Work Order ID 86982

Item Name: Crosstube Fwd

DART AEROSPACE LTD		Work Order:	86982
Description: Crosstube High Fwd (205/212/412)		Part Number:	D212-664-101
Inspection Dwg: D212-664-141 Rev: D		Page 1 of 1

DRAWING NO. D212-664-141	TITLE XTUBE ASSY (205/212/412 HI FWD)	REV. D	DART AEROSPACE LTD ENGINEERING ORDER		D.E.O. NO. D212-664-141-D-1	SHEET NO. SHEET 1 OF 2	SCALE NTS
DRAWN	CHECKED	MFG. APPR.	APPROVED	DE APPR.			
DATE 11.04.07	DATE 11.07.11	DATE 11.04.12	DATE 11/04/12	DATE 11.04.12

D212-664-141/-141B
ASSEMBLY DETAIL

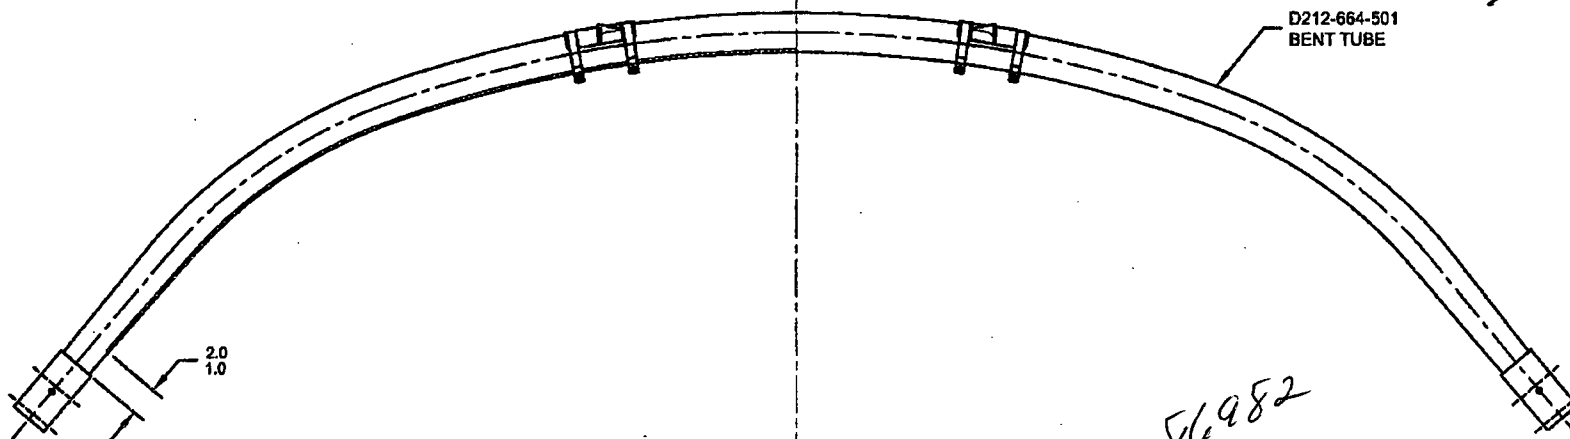
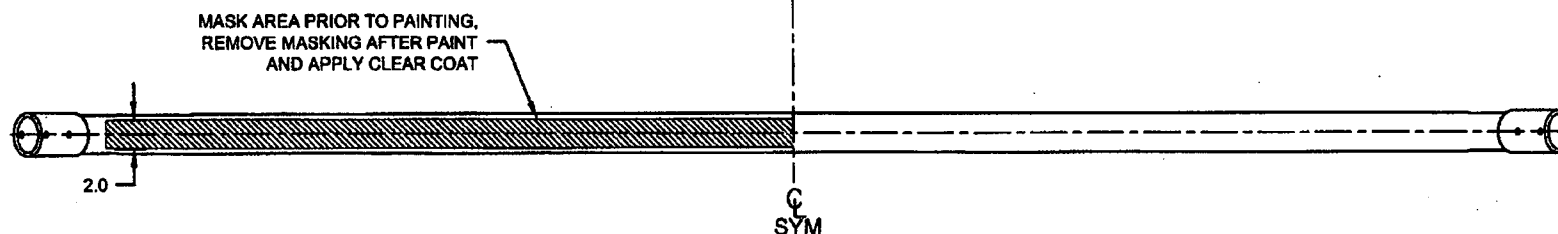
PURPOSE:

ADD AN INSPECTION WINDOW TO UNDERSIDE OF CROSSTUBE.

NOTES 2 OF SHEET 1 IS AMENDED AS FOLLOWS:

- 2) FINISH: CHEMICAL CONVERSION COAT PER DART QSI 005 4.1
PRIME INSIDE AND OUTSIDE PER DART QSI 005 4.2
MASK UNDERSIDE OF CROSSTUBE AS SHOWN (HATCHED AREA) AND
PAINT OUTSIDE PER DART QSI 005 4.2
REMOVE MASKING AND APPLY CLEAR COAT

- 2) FINISH: CHEMICAL CONVERSION COAT PER DART QSI 005 4.1
PRIME INSIDE AND OUTSIDE PER DART QSI 005 4.2
PAINT OUTSIDE PER DART QSI 005 4.2
